IRON HAMMER AT CENTRETECH - SITE PLAN AMENDMENT

SITE PLAN AMENDMENT
IRON HAMMER AT CENTRETECH
255 LAREDO STREET
AURORA, CO
JESSE DONOVAN, P.E. 720-504-8629

REVISION NUMBER	REVISION DESCRIPTION	DATE
00		09/21/2023
01	FIRST SUBMITTAL	02/05/2024
	SECOND SUBMITTAL

SITE PLAN

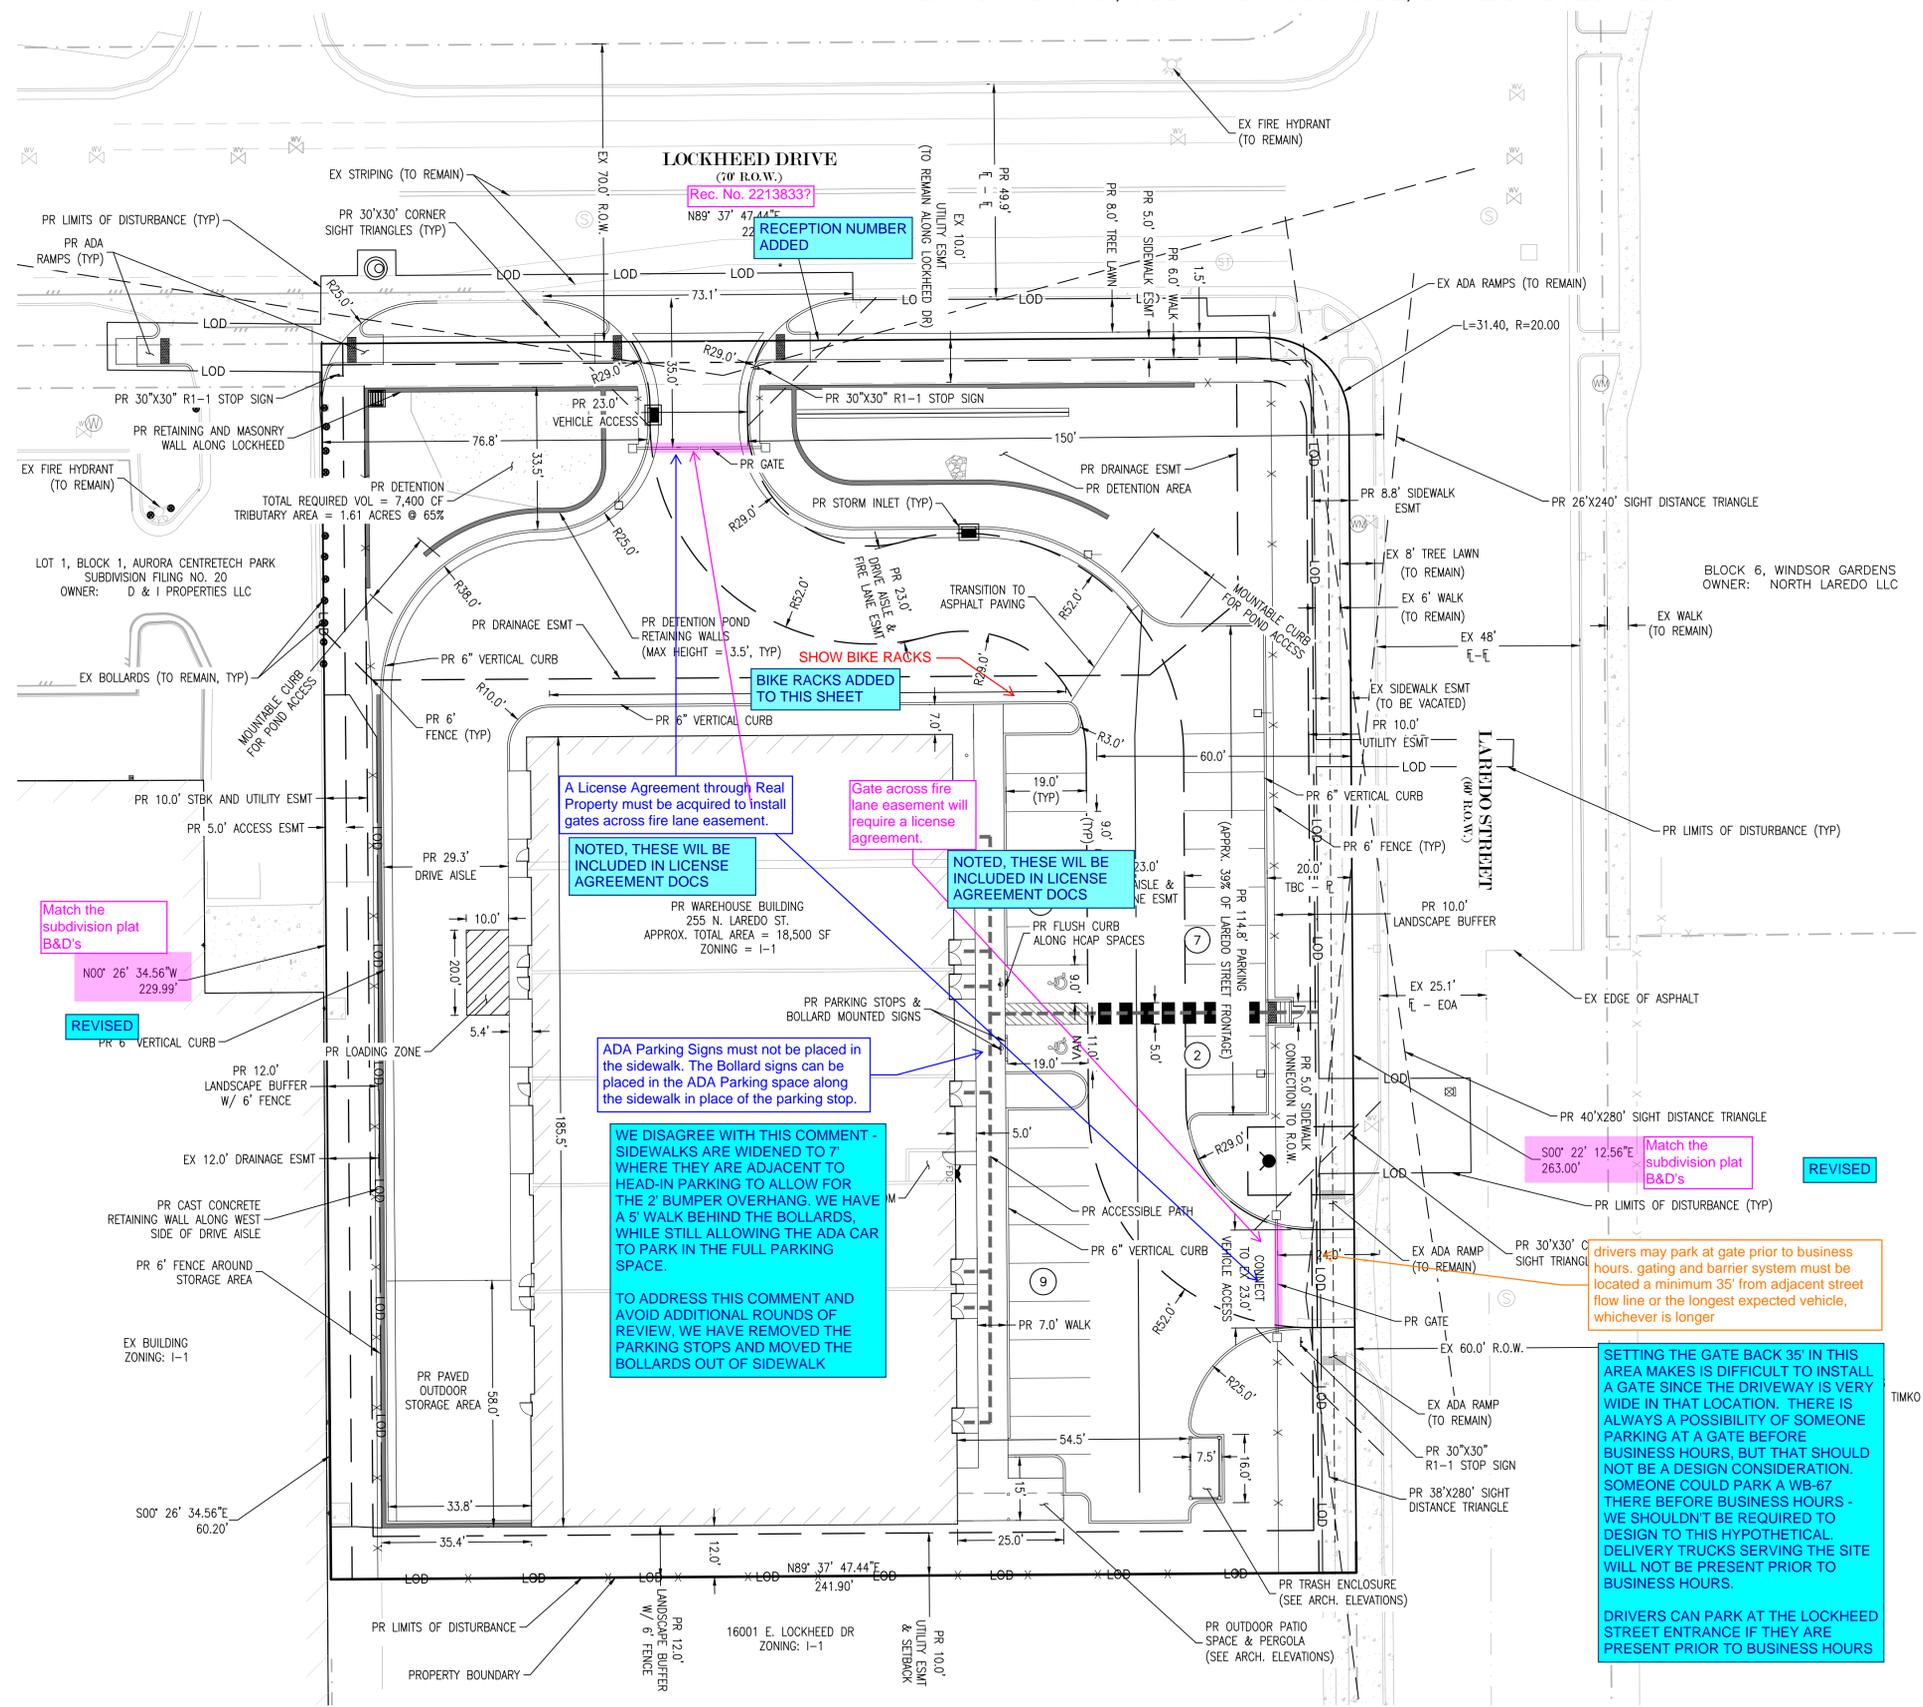
For Lockheed Dr. and Laredo St., identify the following information as part of the site plan submittal in conformance with Section 2.12.0.1 of the Roadway Manual either on a section detail or in a table:

Roadway classification (typical section name)
Adjacent land use category
Number of lanes
Back-to-back curb width
Pedestrian activity level (medium for both streets)
Pavement Type (R3)

A License Agreement through Real Property must be acquired to install gates across fire lane easement.

Gate across fire lane easement will require a license agreement.

ADA Parking Signs must not be placed in the sidewalk. The Bollard signs can be placed in the ADA Parking space along the sidewalk in place of the parking stop.

drivers may park at gate prior to business hours, gating and barrier system must be located a minimum 35' from adjacent street flow line or the longest expected vehicle, whichever is longer

Match the subdivision plat B&D's

Match the subdivision plat B&D's

TABLE ADDED TO THIS SHEET

NOTED, THESE WILL BE INCLUDED IN LICENSE AGREEMENT DOCS

NOTED, THESE WILL BE INCLUDED IN LICENSE AGREEMENT DOCS

WE DISAGREE WITH THIS COMMENT - SIDEWALKS ARE WIDENED TO 7' WHERE THEY ARE ADJACENT TO HEAD-IN PARKING TO ALLOW FOR THE 2' BUMPER OVERHANG. WE HAVE A 5' WALK BEHIND THE BOLLARDS, WHILE STILL ALLOWING THE ADA CAR TO PARK IN THE FULL PARKING SPACE.

TO ADDRESS THIS COMMENT AND AVOID ADDITIONAL ROUNDS OF REVIEW, WE HAVE REMOVED THE PARKING STOPS AND MOVED THE BOLLARDS OUT OF SIDEWALK

SETTING THE GATE BACK 35' IN THIS AREA MAKES IS DIFFICULT TO INSTALL A GATE SINCE THE DRIVEWAY IS VERY WIDE IN THAT LOCATION. THERE IS ALWAYS A POSSIBILITY OF SOMEONE PARKING AT A GATE BEFORE BUSINESS HOURS, BUT THAT SHOULD NOT BE A DESIGN CONSIDERATION. SOMEONE COULD PARK A WB-67 THERE BEFORE BUSINESS HOURS - WE SHOULDN'T BE REQUIRED TO DESIGN TO THIS HYPOTHETICAL. DELIVERY TRUCKS SERVING THE SITE WILL NOT BE PRESENT PRIOR TO BUSINESS HOURS.

DRIVERS CAN PARK AT THE LOCKHEED STREET ENTRANCE IF THEY ARE PRESENT PRIOR TO BUSINESS HOURS

REVISED

REVISED

OVERALL GRADING PLAN

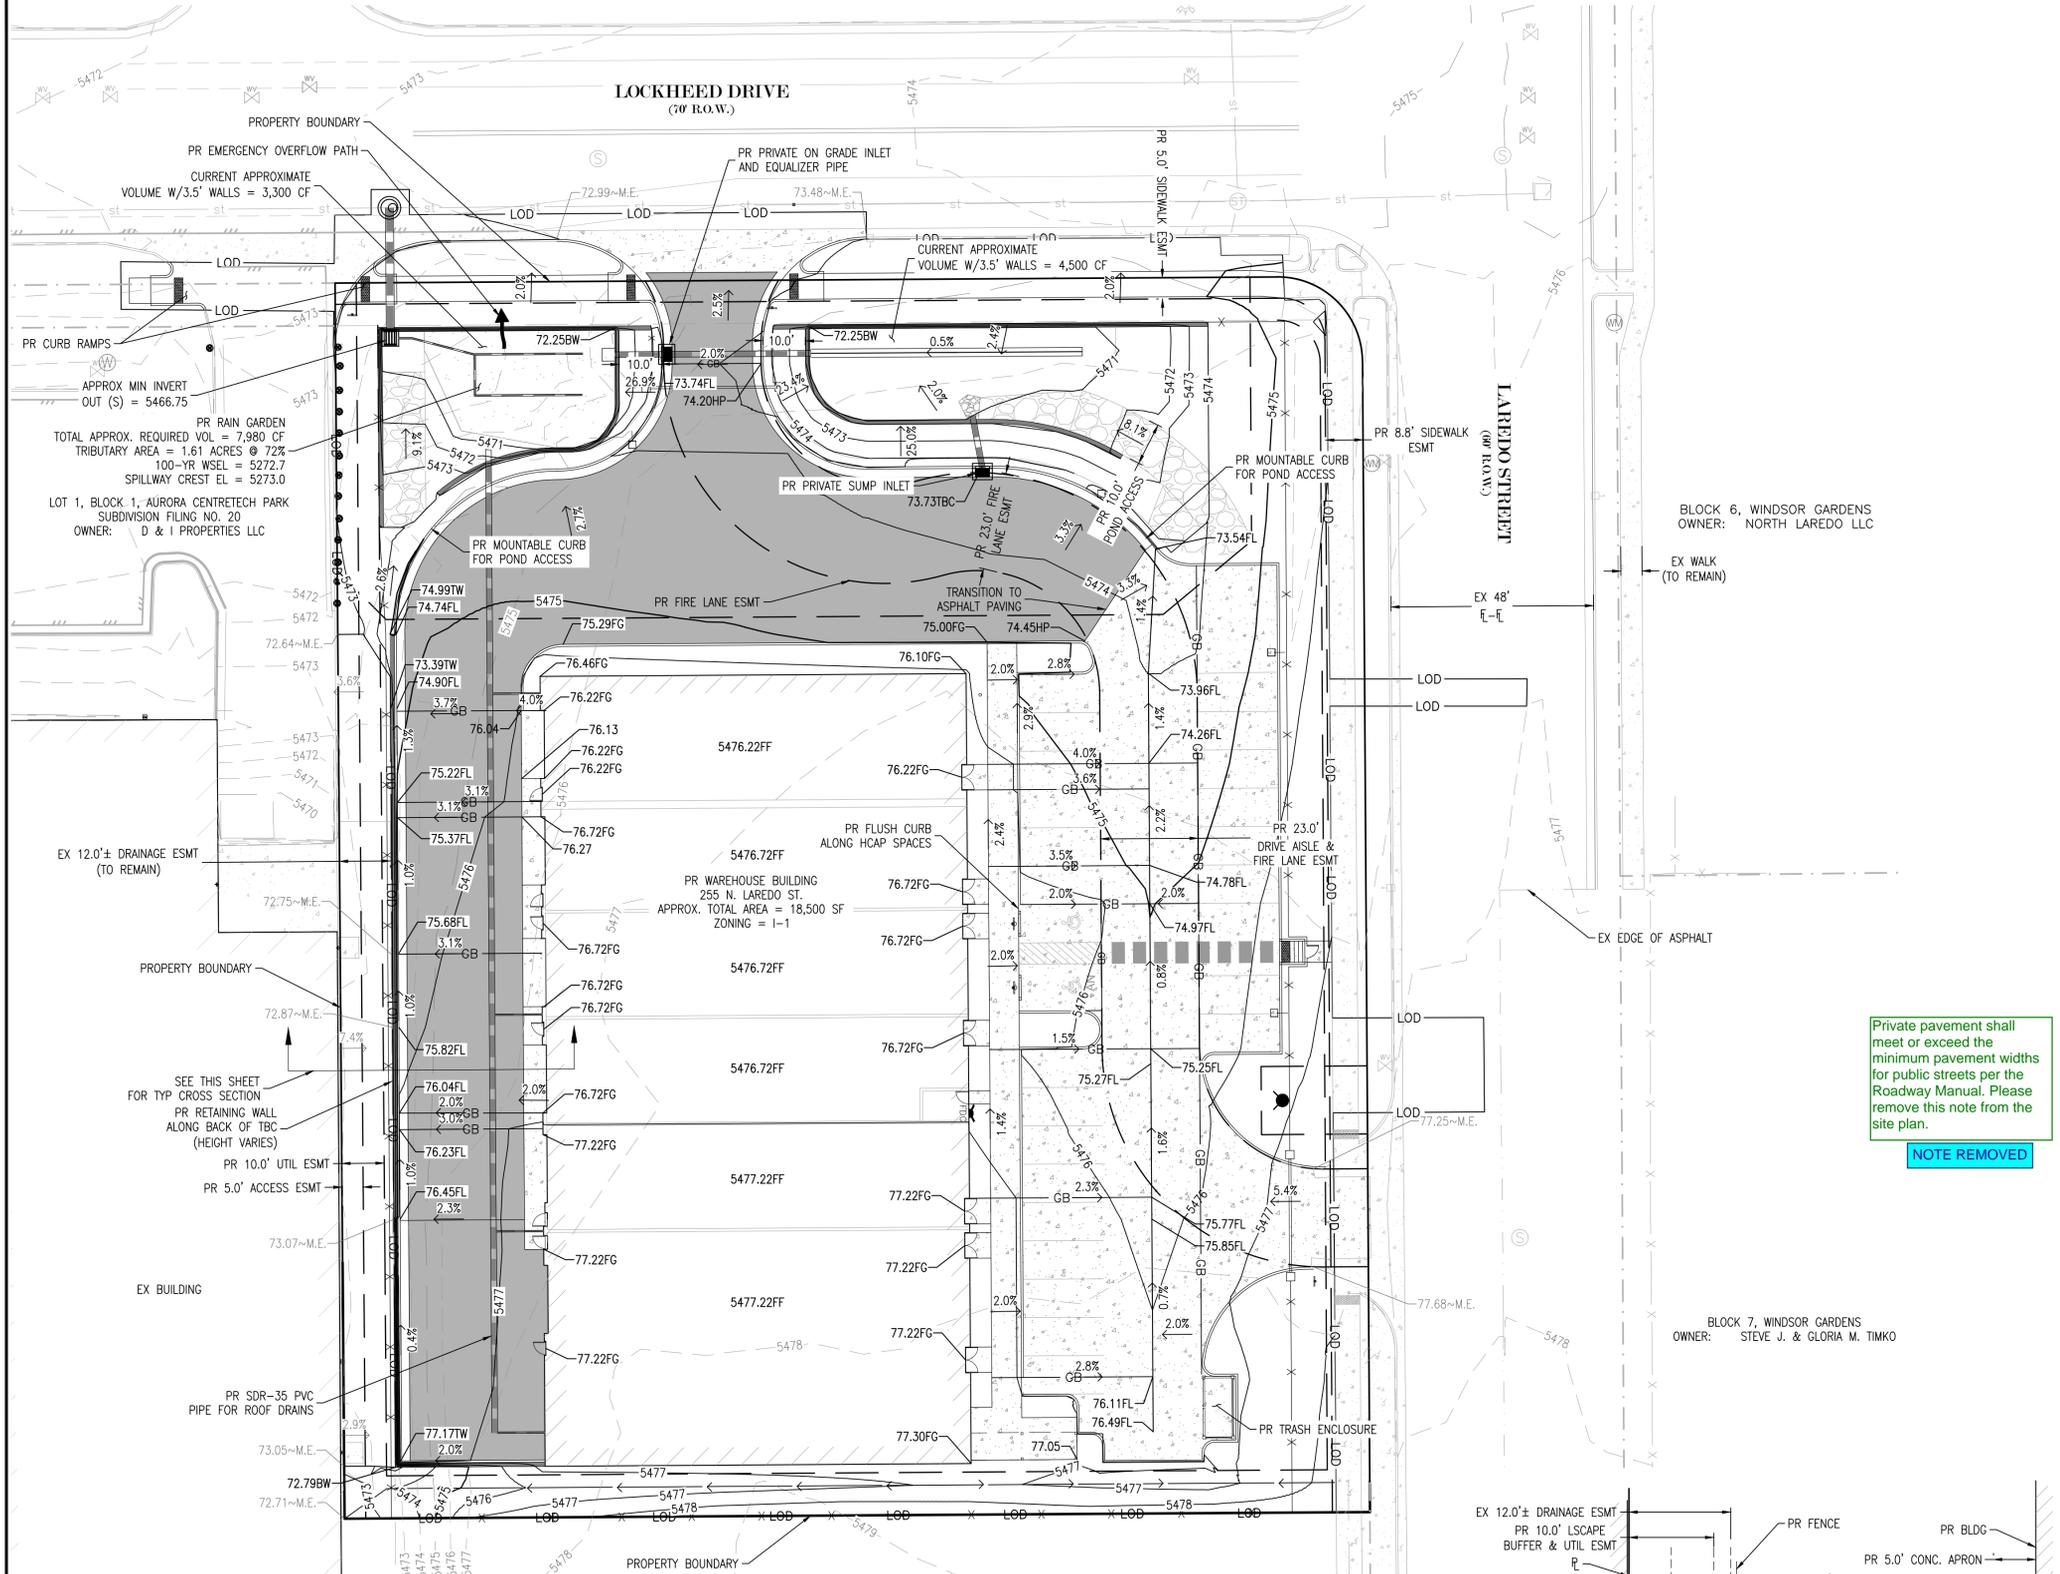
Private pavement shall meet or exceed the minimum pavement widths for public streets per the Roadway Manual. Please remove this note from the site plan.

NOTE REMOVED

OVERALL UTILITY PLAN

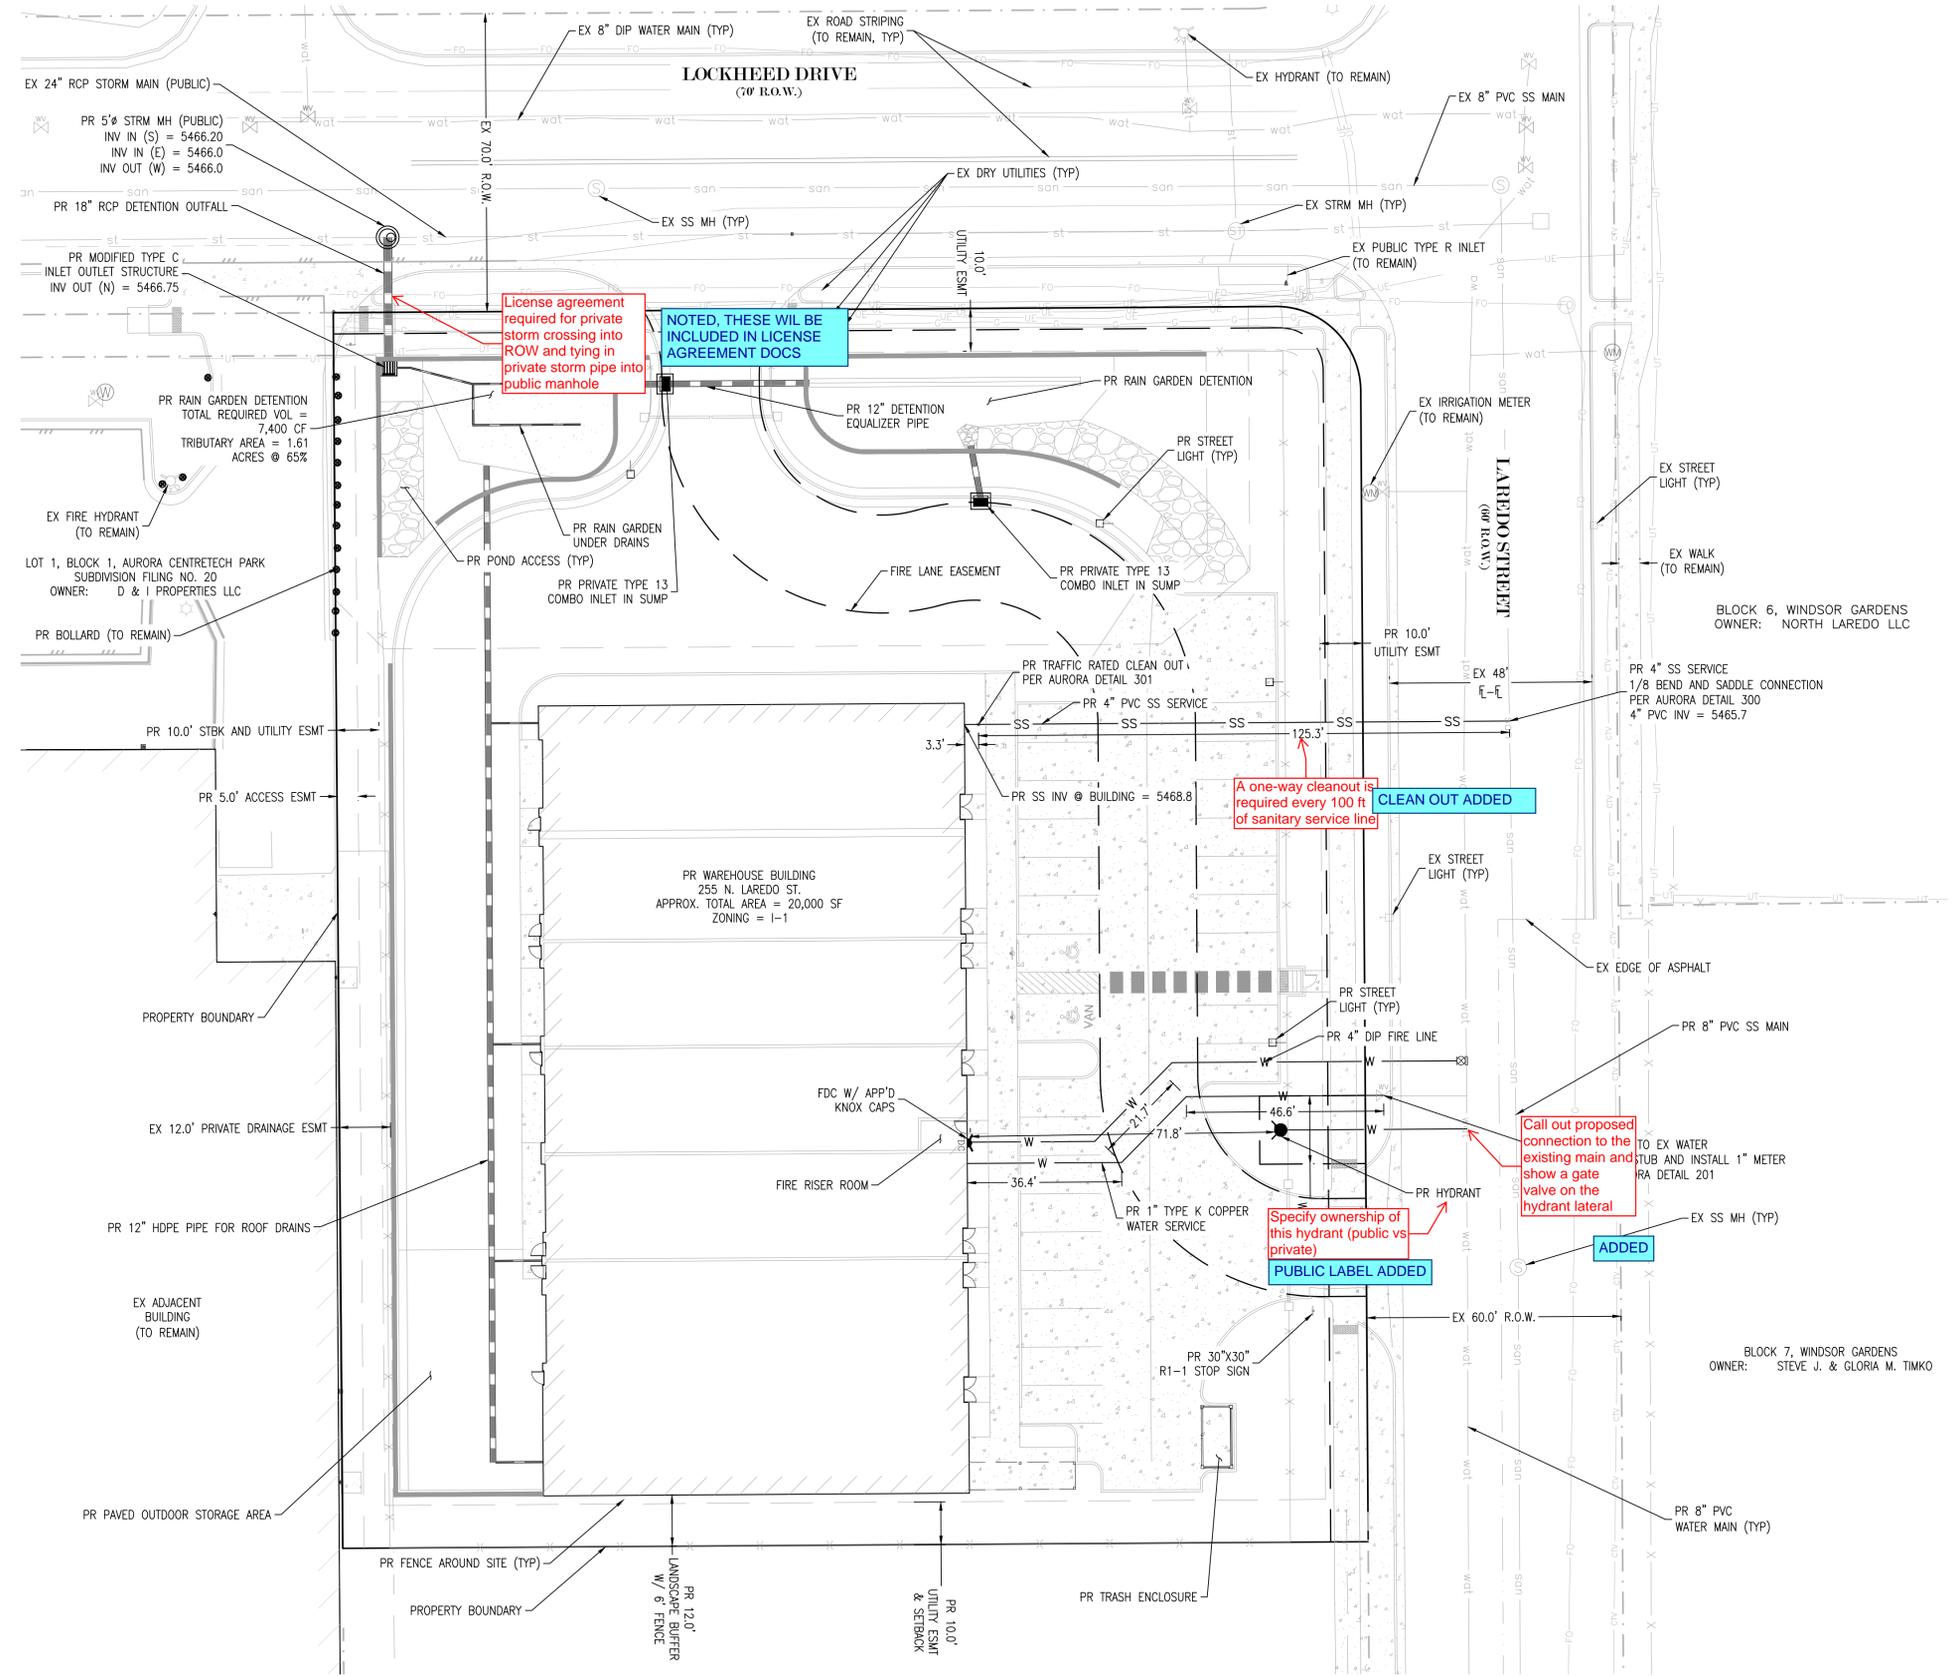
Please be advised that a civil plan revision will be required before the new tap can be made. Consider confirming the location and size of the existing stub prior to civil plan submission

NOTED
